**TO:** Dr. Jesse Bacon, Superintendent  
**FROM:** Danny Clemens, Director of Facilities  
**Date:** January 21, 2024  
**RE:** BEHS Fine Arts Change Order 19 - Band and Chorus Room Framing **DC**

**PROJECT:** *(Name and address)*  
 Bullitt East High School Fine Arts Addition  
 11450 KY-44, Mt Washington, KY 40047

**CHANGE ORDER INFORMATION:**  
 Change Order Number: 019  
 Date: January 27, 2025

Re: BEHS-Fine Arts Addition/COR #31/RFP #21/Added Drywall & Soffits in Band & Chorus Rooms

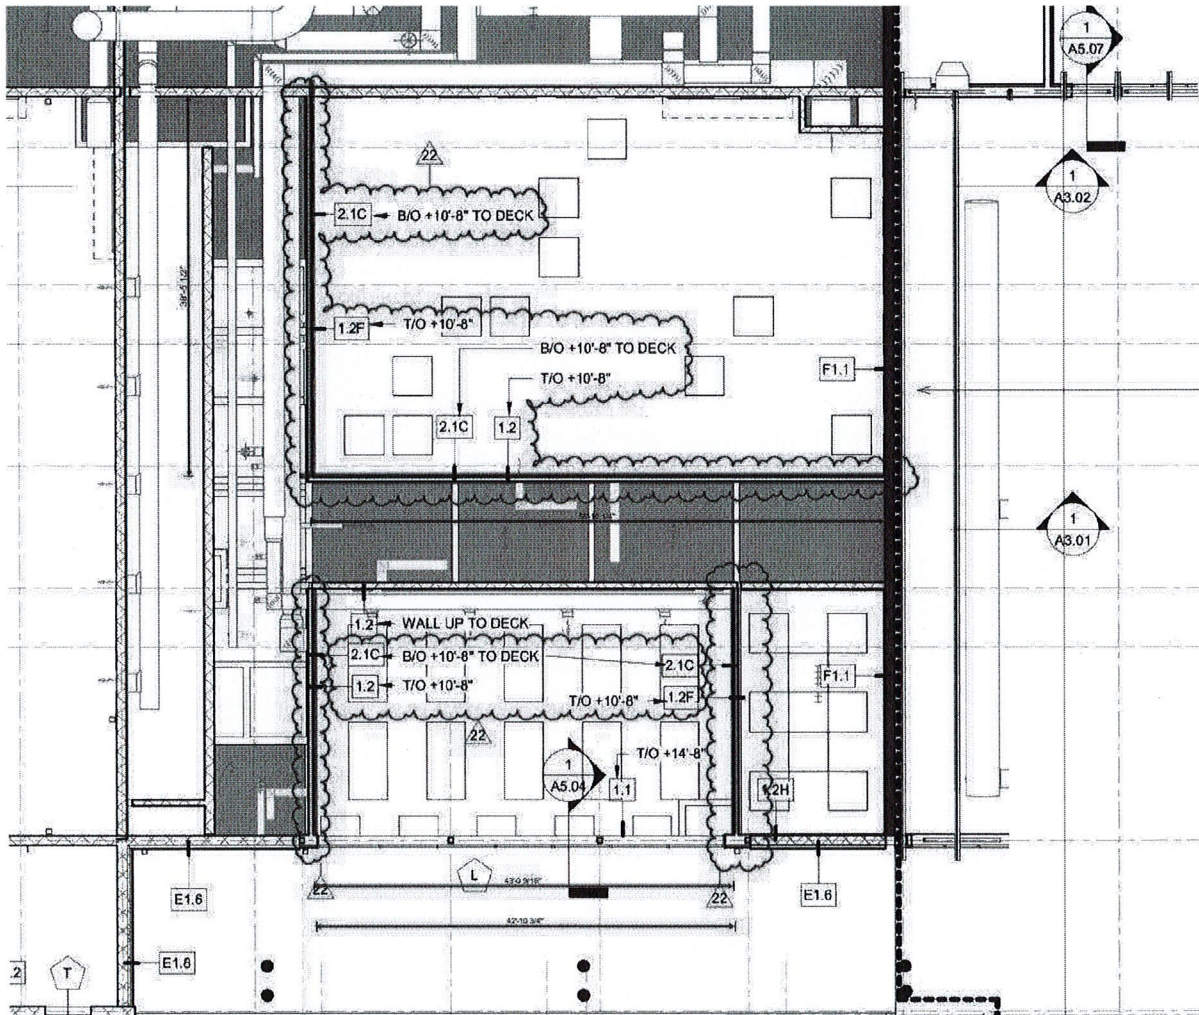
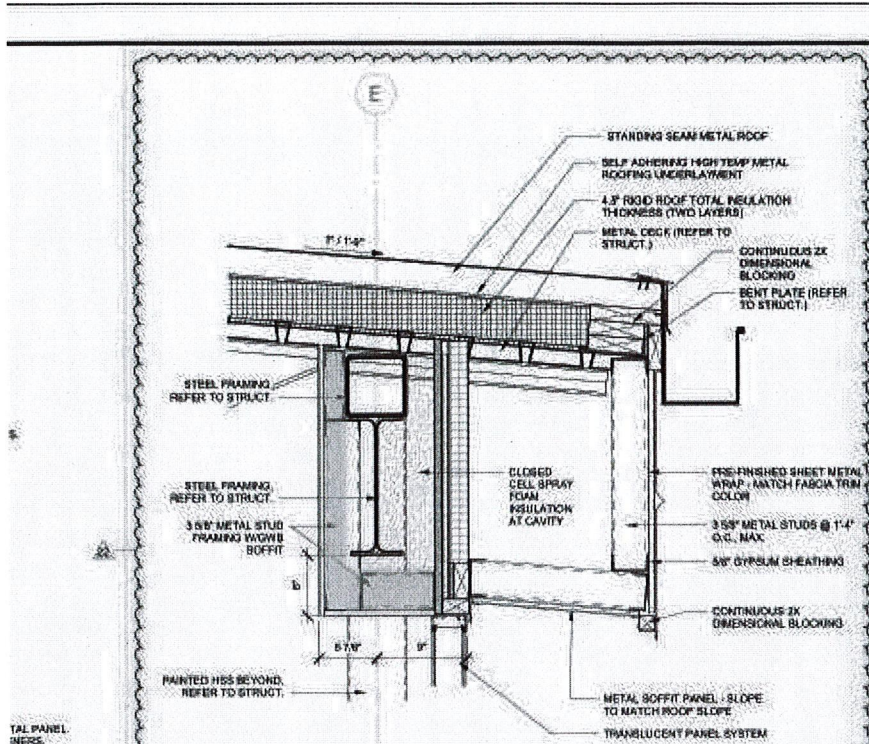
**Masonry walls to roof deck revised to stud framing as clouded.**

9 DETAIL - TRANSLUCENT PANEL @ CHOIR  
1/2" = 1'-0"

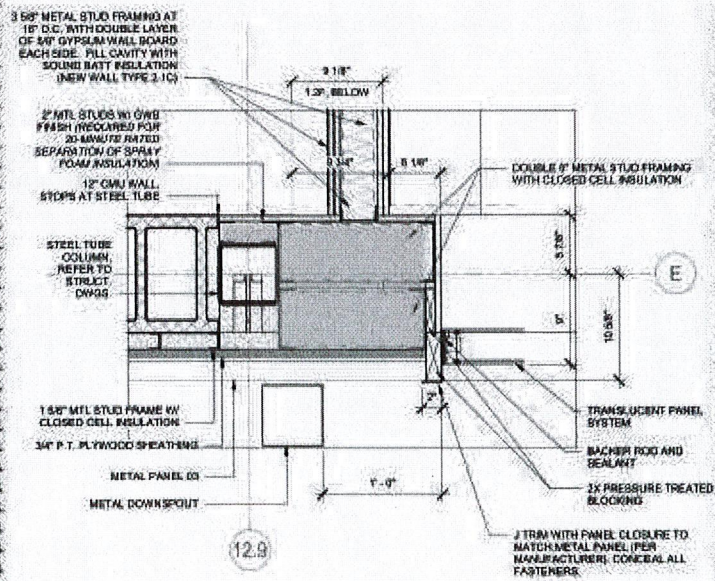
**Jamb and Head Details revised at Translucent Panel "L".**
